Warnvermerk / Warning notice	DIN 25192:2026-11
Datum / Date	2026-10-23
Verbindungselemente — Hammerschrauben für Schienenfahrzeuge Fastening elements — T-head bolts (hammer head bolts) for railway vehicles Éléments de fixation — Vis à tête rectangulaire pour véhicules ferroviaires	
In der deutschen Fassung der DIN 25192:2026-11 wurden folgende Fehler erkannt:	
<p>Die Zeichnung des Kopfes ist nichtzutreffend.</p> <p>Das Hauptunterscheidungsmerkmal einer Hammerschraube mit einseitig gerundeten Kopf Form B nach DIN 25192 zur Hammerschraube DIN 261 ist der Radius.</p> <p>Dieser Radius ist in der aktualisierten Norm an einer falschen Stelle eingezeichnet und stellt funktionsmäßig eine völlig andere Schraube dar.</p> <p>Die Bilder 001a und 001b sind durch folgende Bilder zu ersetzen:</p>	
<p style="text-align: center;"><i>Linsenkuppe nach Wahl des Herstellers zulässig</i></p>  <p>The drawing consists of three views: a side view (top left), a side view (bottom left), and an end view (top right). The side view (top left) shows a T-shaped head with a 45° chamfer on the left side, a 1:20 slope on the top left, and a radius r_1 at the top right corner. Dimensions include k (total head width),

Images 001a and 001b shall be replaced with the following images:

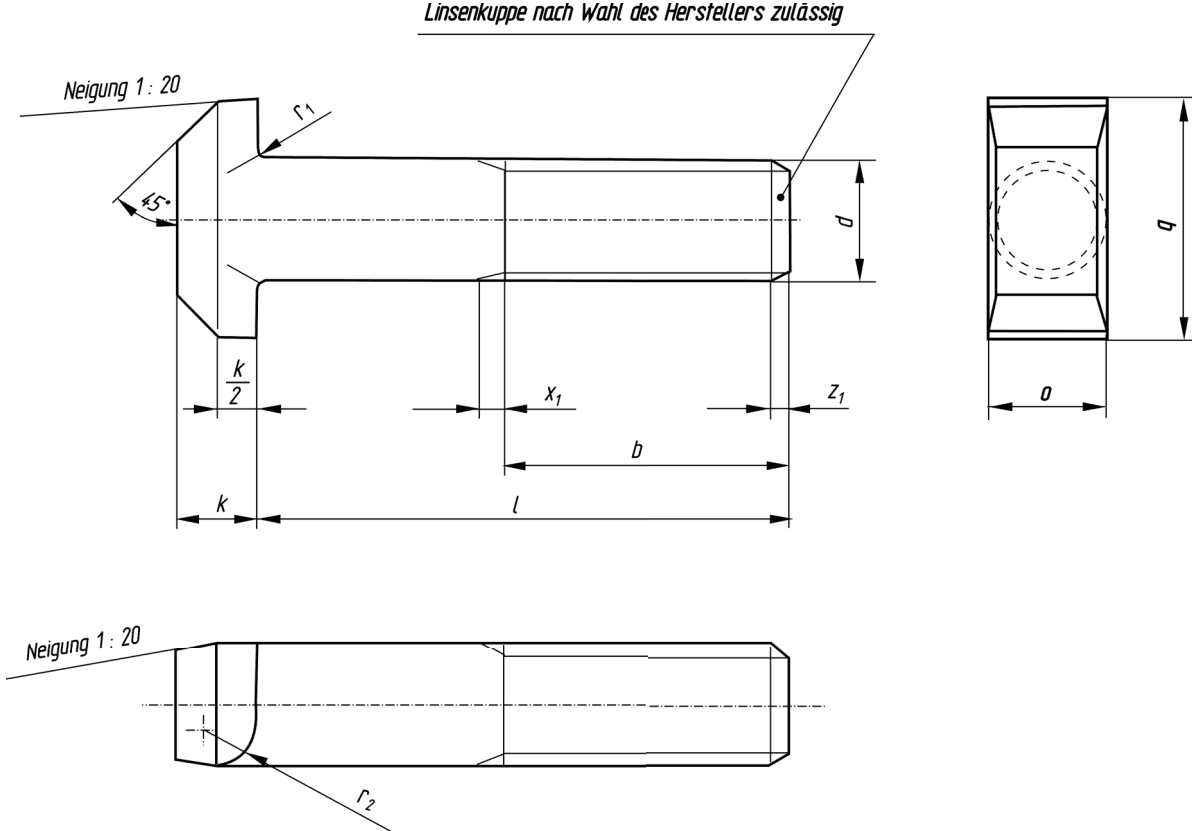
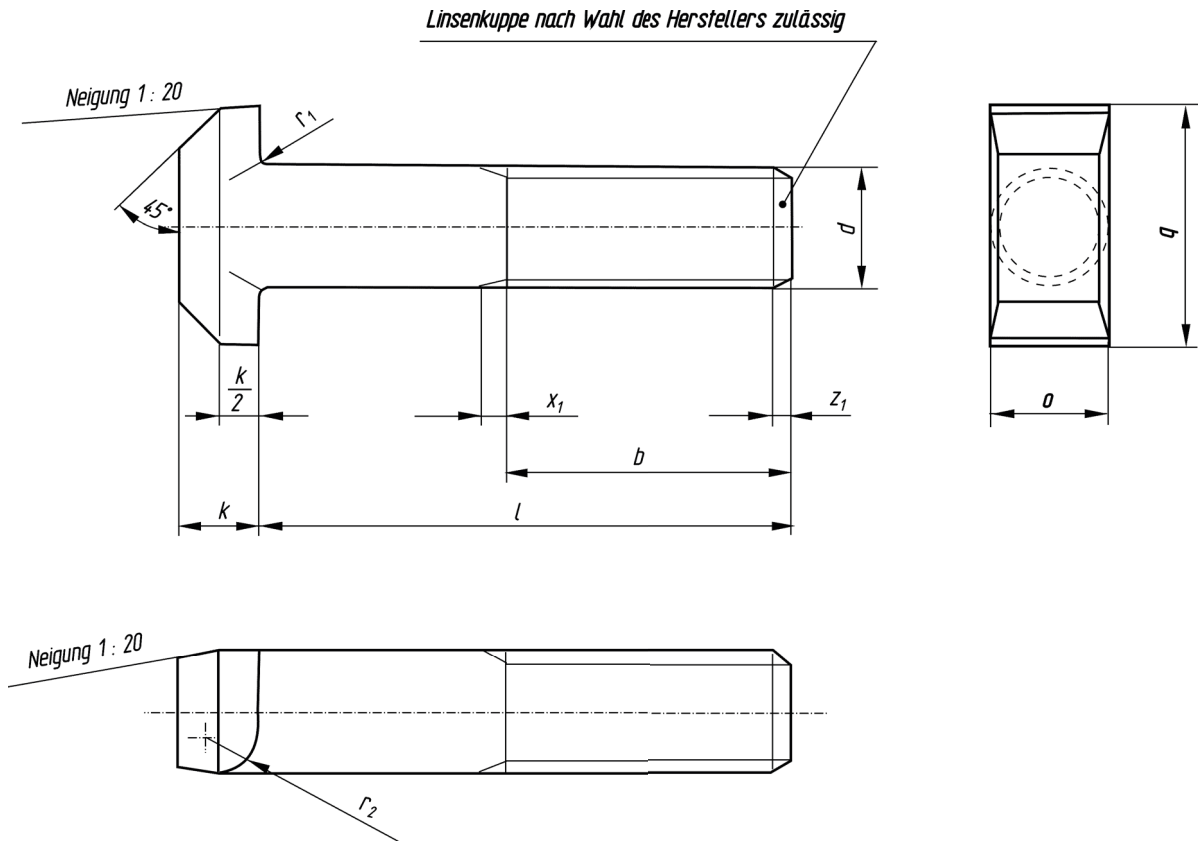
In the German version of DIN 25192:2026-11 the following errors have been noted:	
<p>The drawing of the head is not correct.</p>

The main distinguishing feature of a hammer-head bolt with a head rounded on one side, Form B according to DIN 25192, compared to a hammer-head bolt according to DIN 261, is the radius.

In the revised standard, this radius is shown in the wrong location and therefore represents a completely different bolt from a functional point of view.
